FIELD INSPECTION

Project Name:	Mountain Valley Pipeline	Inspector:	Matthew Grant
Inspection Date:	Wednesday, November 28, 2018	Project Contact:	Brian Clauto
Spread: Franklin County MP 261 St#13814-13808	Spread I	Weather (Wet/Dry/Rain):	Wet

FIELD INSPECTION PHOTO LOG

Fig. 1 St#13819+01 slope is showing signs of erosion

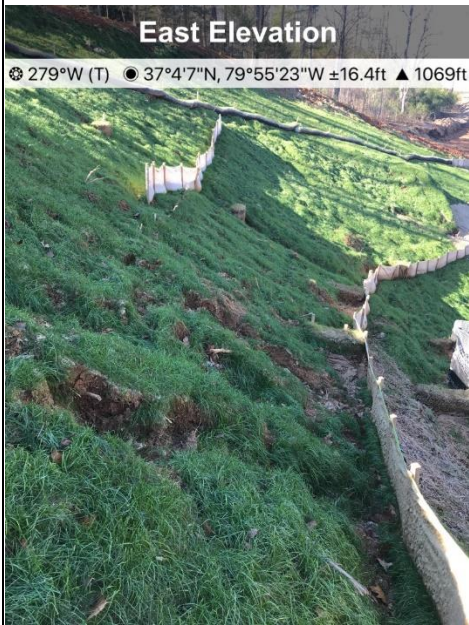
- St#13819+01 slope is showing signs of erosion
- St#13811 construction entrance has sediment in stone, silt fence is at capacity of maintenance, sump requires maintenance
- St#13808+74 waterbar flow path has eroded and sump has filled

Recommended Corrective Action: repair and maintain all controls per the approved plan.
